V-90
(2015)

MAP OF ASBUILT SURVEY & IMPERVIOUS CALCULATION FOR
ANAND SHAH & NIMISHA SHAH
 2290 VALLA COURT, MARIETTA, GEORGIA
 LAND LOT 95B, 16th DISTRICT, 2nd SECTION
 LOT 1, THE PARC, PLATBOOK 264, PAGE 30
 FIELD DATE: 03/25/2015, MAP DATE 03/30/2015

PETITION No.: V-90

TYPE OF VARIANCE: To increase the maximum allowable impervious surface from 35% to 40%.

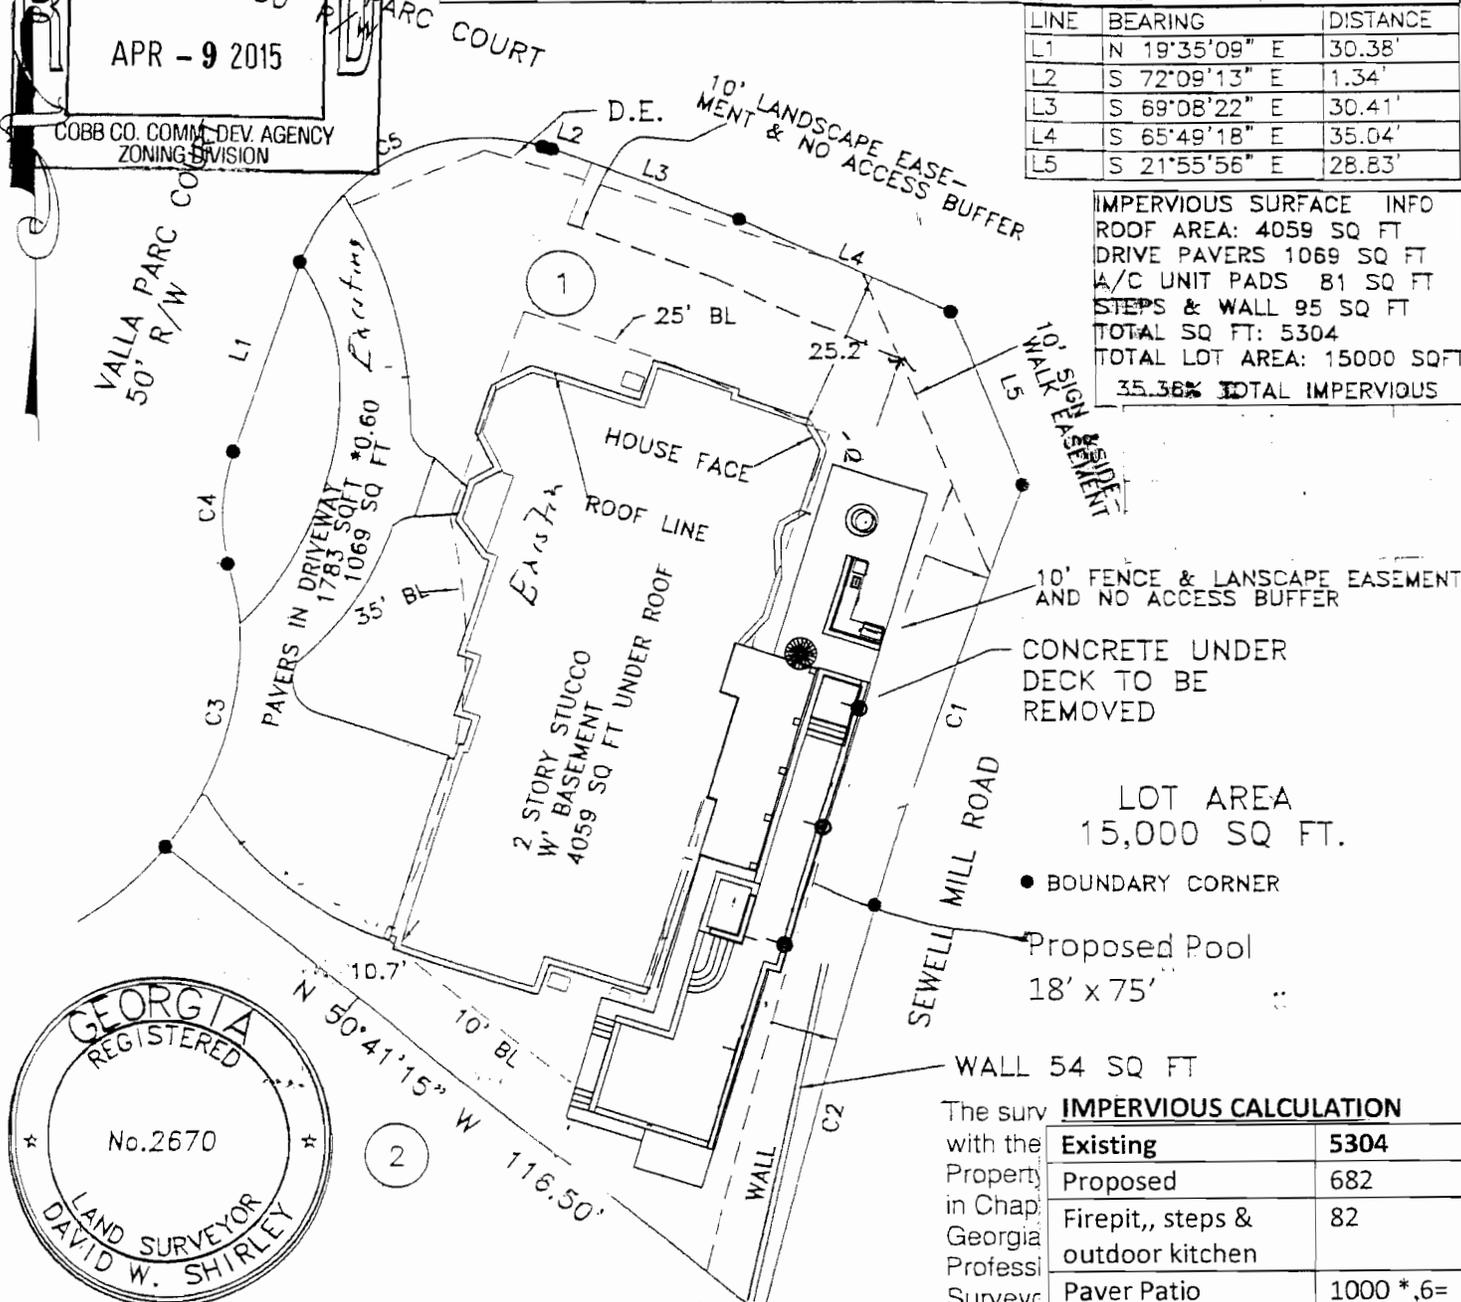
SITE PLAN REVIEW: If this variance request is approved, a subdivision plat revision must be recorded prior to the issuance of the certificate of occupancy showing all improvements on the lot and referencing the variance case in the standard plat revision note. The surveyor must submit the plat to the Site Plan Review Section, Community Development Agency for review and approval prior to recording. Call 770-528-2147.

STORMWATER MANAGEMENT: Owner has already installed pervious pavers for driveway and an infiltrator system that captures runoff from 2,053 square feet of roof area. The actual effective impervious coverage is well under the 35% allowable.
